City of Franklin

Meeting Agenda

Historic Zoning Commission

Monday, September 14, 2026

MOST
RECENT
ADDITION

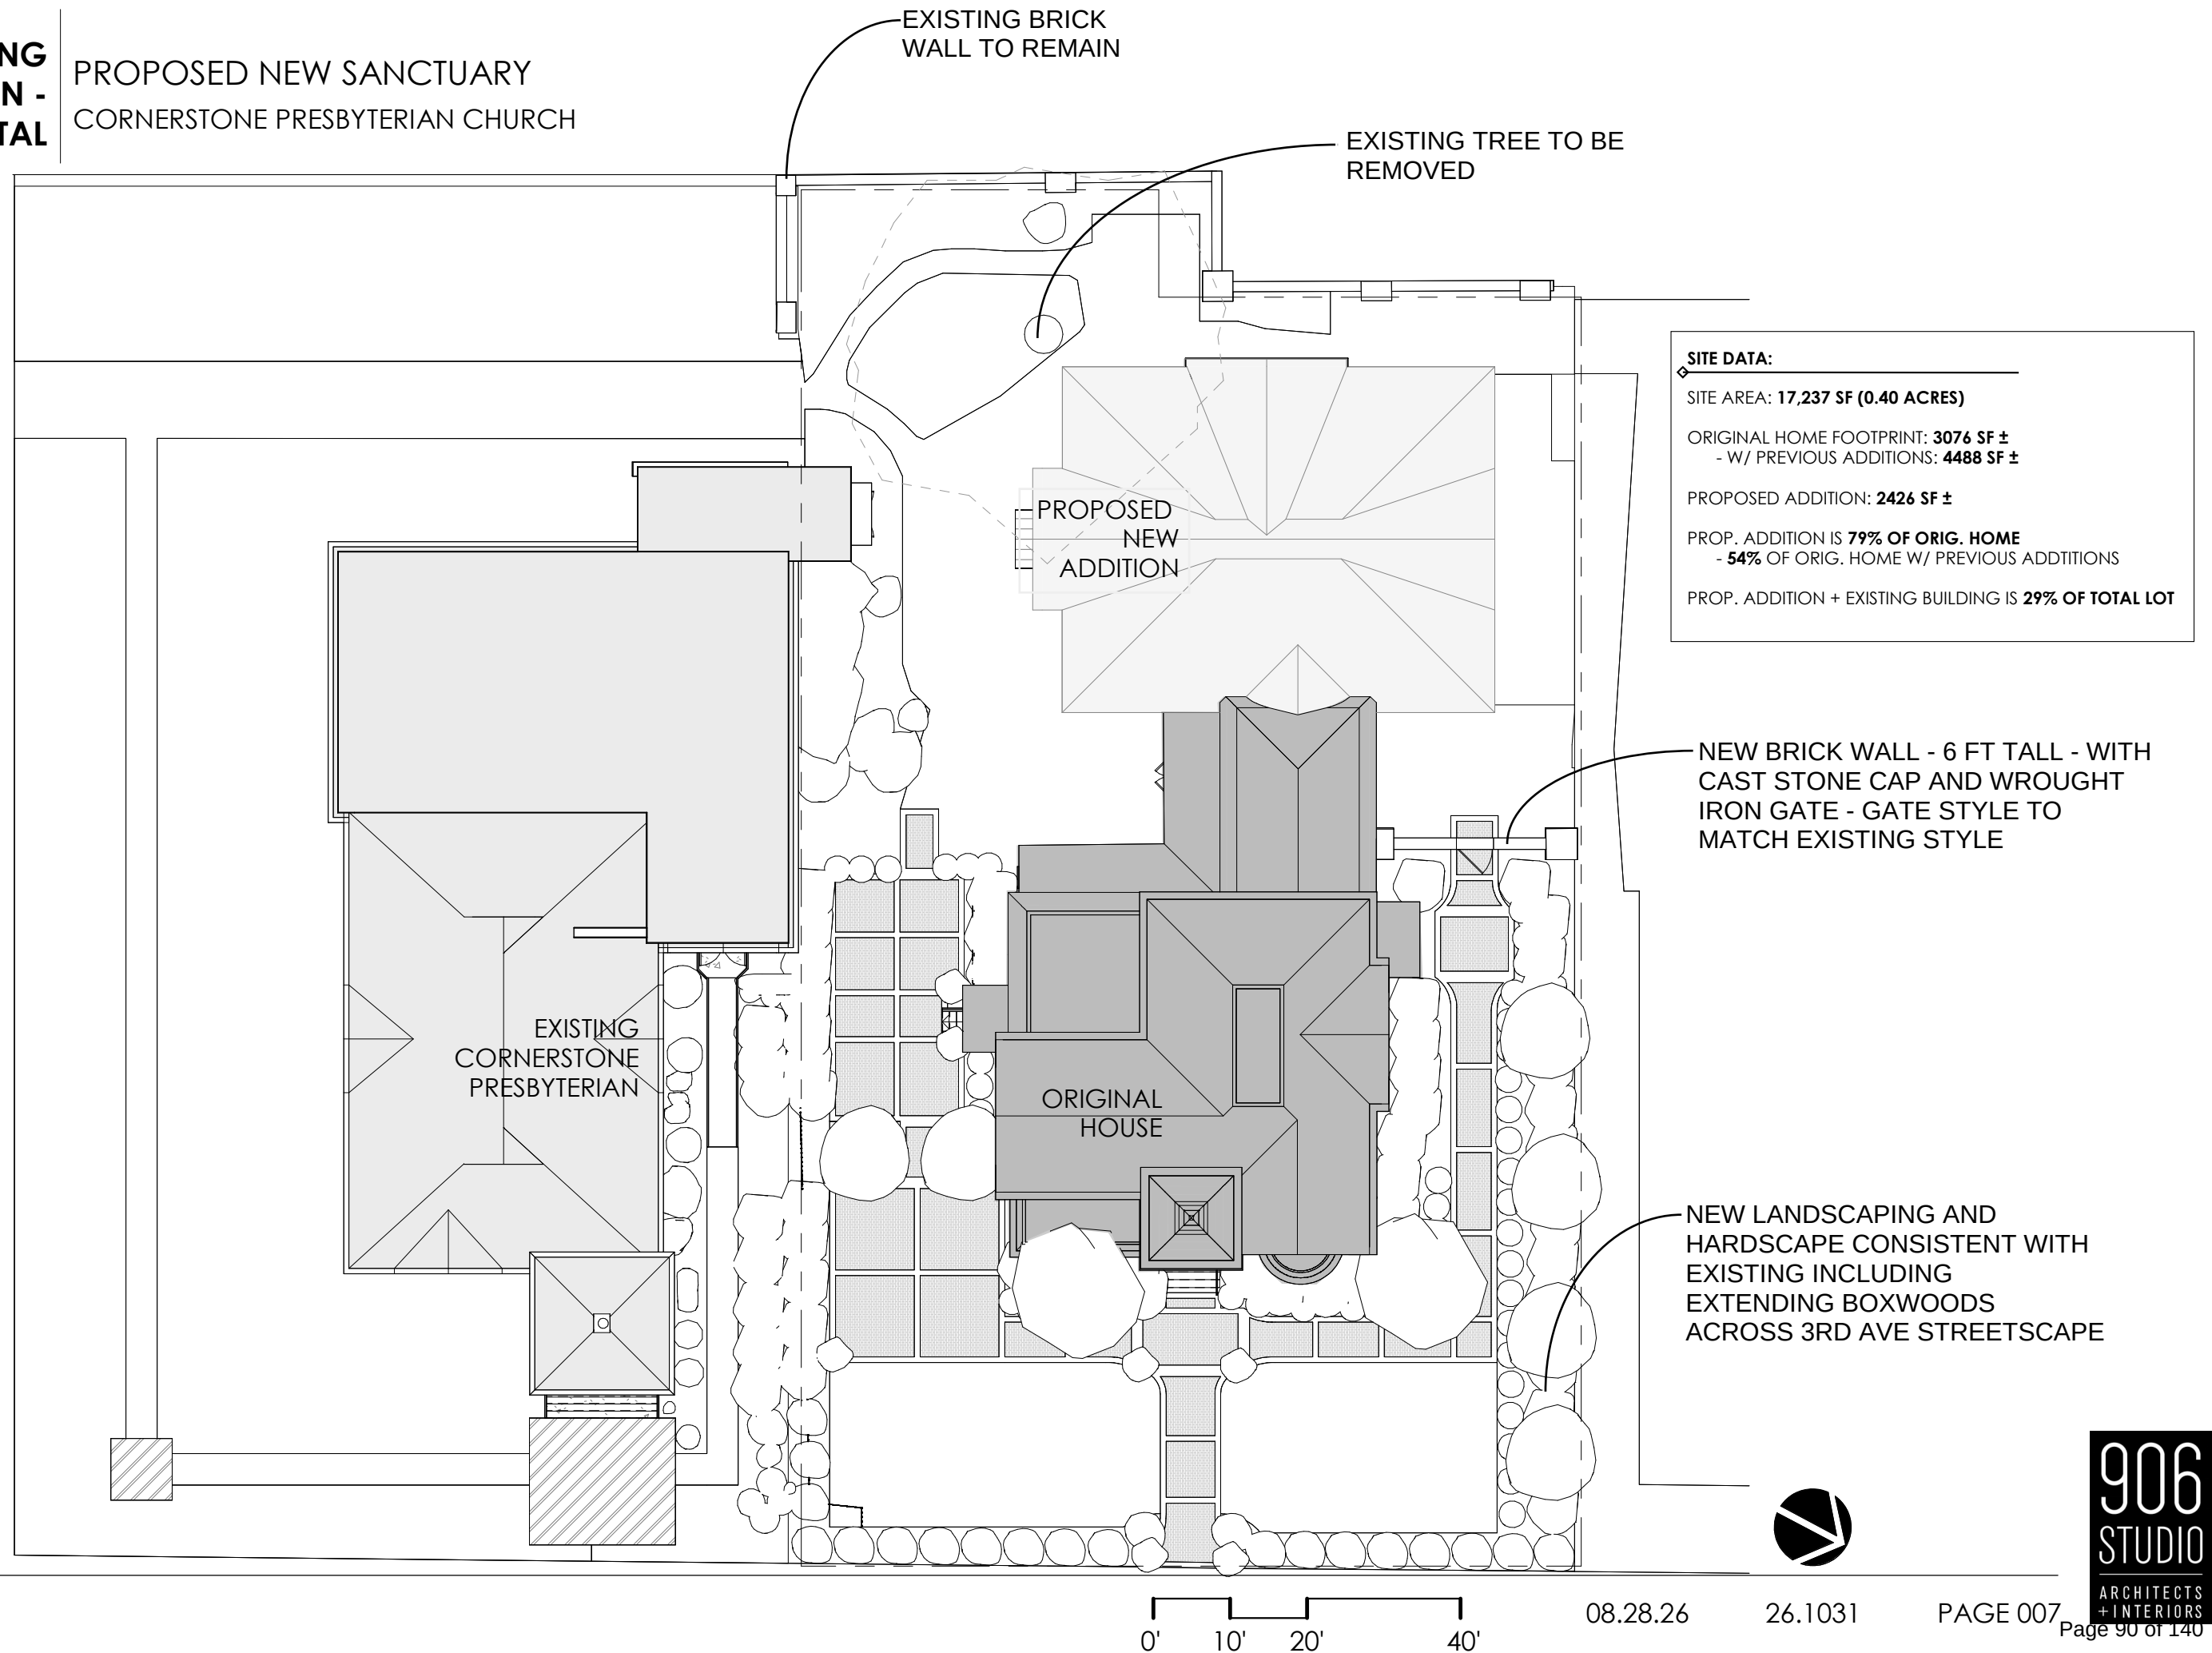
The first is the addition of hardscaping around the building. The hardscaping visible from 3rd Avenue South appears to consist of a dark red paver, and to the rear of the site, concrete will be used. Both of these materials are supported by the Guidelines. However, their placement is unique, as the Guidelines recommend that, for residential buildings, a landscaped front yard be provided and paved or hardscape areas be minimized. Traditional lawn areas should not be replaced with hardscaping. The left side of the building has added hardscaping that measures 20' in width. The amount of hardscaping in the front yard should be minimized to align with the Guidelines.

At the rear of the property is an existing 7' tall brick wall. It is proposed to match the design of the wall and include a wrought iron gate on the right side of the property, where the driveway is located now. The wall and gate align with the Guidelines recommendations. However, the design of the gate was not included and should be returned to the Preservation Planner for review to ensure it has traditional characteristics.

It is proposed to restore the historic building and remove the existing aluminum siding with an 8" exposure and replace the siding with painted wood siding. The new siding is proposed to be 6" in exposure. The exposure should be consistent with what was historically on the building, if any siding remains. The siding should be restored if intact. If the siding is not there, new lap siding with an exposure of 4" is recommended as that is consistent with the architectural style of the building. The Guidelines support the removal of synthetic siding, restoring the original siding materials, and installing new siding.

It is proposed to remove the rear addition on the building and the tent structure at the rear of the building. The addition is believed to have been constructed circa 1990 and the age of the tent structure is circa 2000. The Guidelines support removing both.

1. The hardscaping in the front yard should be minimized to align with the Guidelines. The hardscaping and landscaping plan shall return to the Preservation Planner for review and approval.

2. The wrought iron gate design shall return to the Preservation Planner for review and approval.
3. The exposure of the lap siding shall be consistent with what was historically there, if it cannot be repaired. If it cannot be restored and new siding should be installed, it must have an exposure of 4".

4. The windows must have a historic profile and dimensions and consist of either wood or a composite material with the appearance of wood. The window and garage door specifications must be approved by the Preservation Planner or the HZC prior to issuance of a building permit.
